PREPARED FOR THE PLAN COMMISSION

Project Address: 1111-1135 Regent Street and 2 South Mills Street (District 13, Alder Evers)
Application Type: Conditional Use and Certified Survey Map
Legistar File ID #: [92236](#) and [92238](#)
Prepared By: Lisa Ernest, AICP, Planning Division
Report Includes Comments from other City Agencies, as noted
Reviewed By: Kevin Firchow, AICP, Principal Planner
Meagan Tuttle, AICP, Planning Division Director

Summary

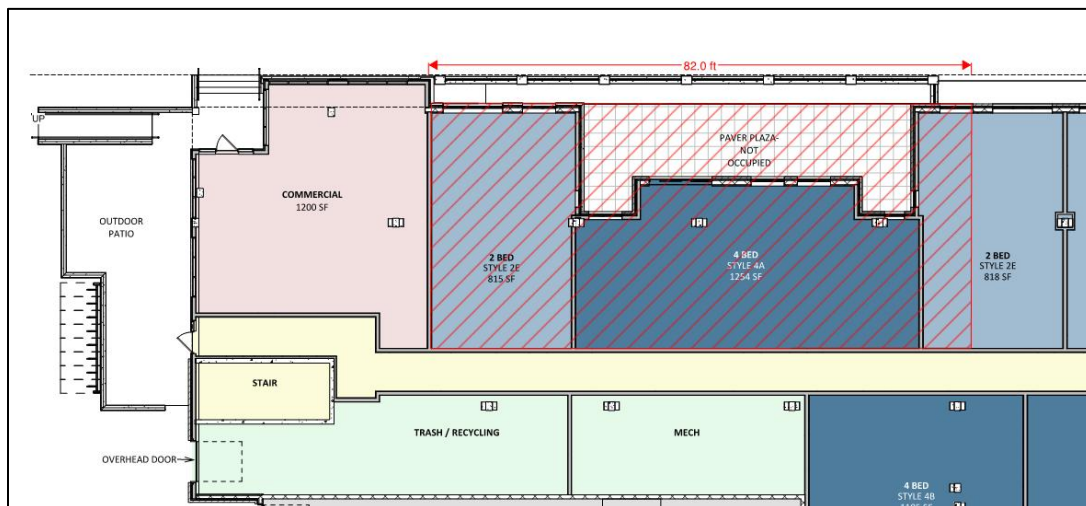
The Zoning Code requires that a minimum of 50% of the frontage along Regent Street has non-residential uses, and that there should be non-residential uses at the street corners. As proposed, approximately 10.6% of the building along Regent Street has commercial frontage. The project includes 1,200 square feet of commercial space at one street corner of the 168,373 square-foot building. There is approximately 339.5 feet of frontage, with 36 feet of commercial frontage along Regent Street. There are 245 feet between the end of the commercial

space and the beginning of the residential lobby on the opposite corners of the building frontage with no residential unit entries in between.

While the Zoning Code allows the Plan Commission to consider a reduction to the required commercial frontage, staff recommends a condition that the project provide more commercial frontage than is currently proposed. Specifically, staff recommend that this project provide a minimum of 35% commercial frontage along Regent Street on at least one street corner. This would require approximately 82 feet of additional commercial frontage for a total of 118 feet.

To find approval standards 3, 4 and 8 met, staff recommend the following condition of approval, “The building shall have approximately 35% of commercial frontage along Regent Street. The commercial frontage shall be provided on at least one street corner. Final details, including resulting façade and site plan changes shall be approved by Planning Division and Zoning Administrator. Significant changes to the building design may require a major or minor alteration as specified in MGO Section 28.183(8).”

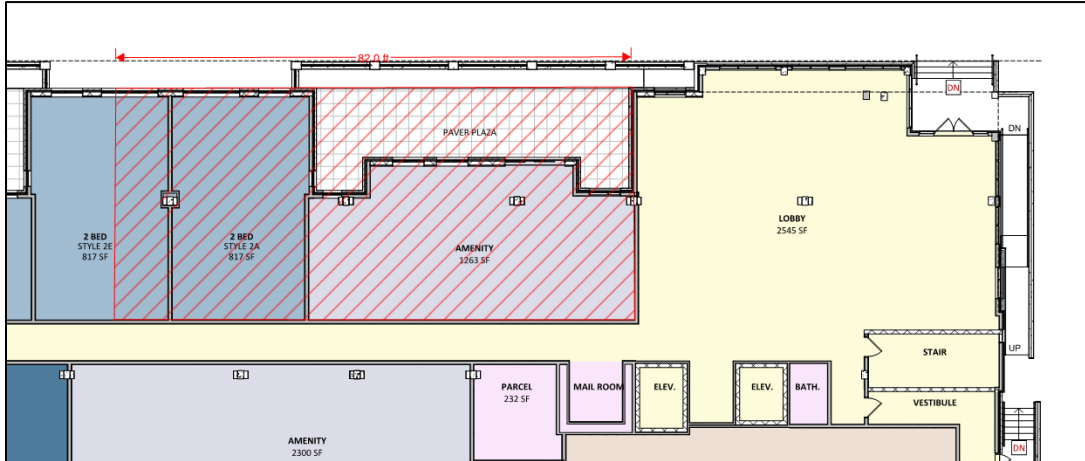
Scenario 1 shows additional commercial frontage next to the existing commercial space. This would remove approximately 2,346 square feet of residential space.

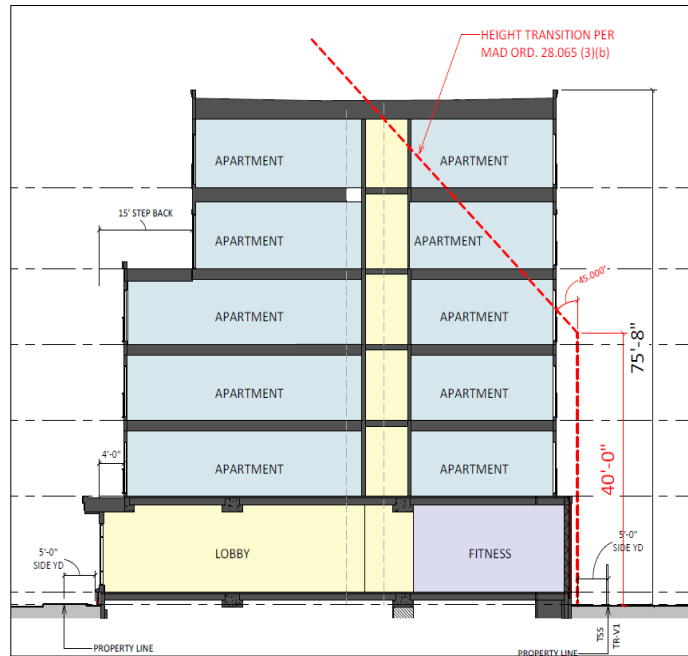
Scenario 2 shows additional commercial frontage at the east end of the building next to the residential lobby. This would remove approximately 1,127 square feet of residential space and 1,218 square feet of amenity space.
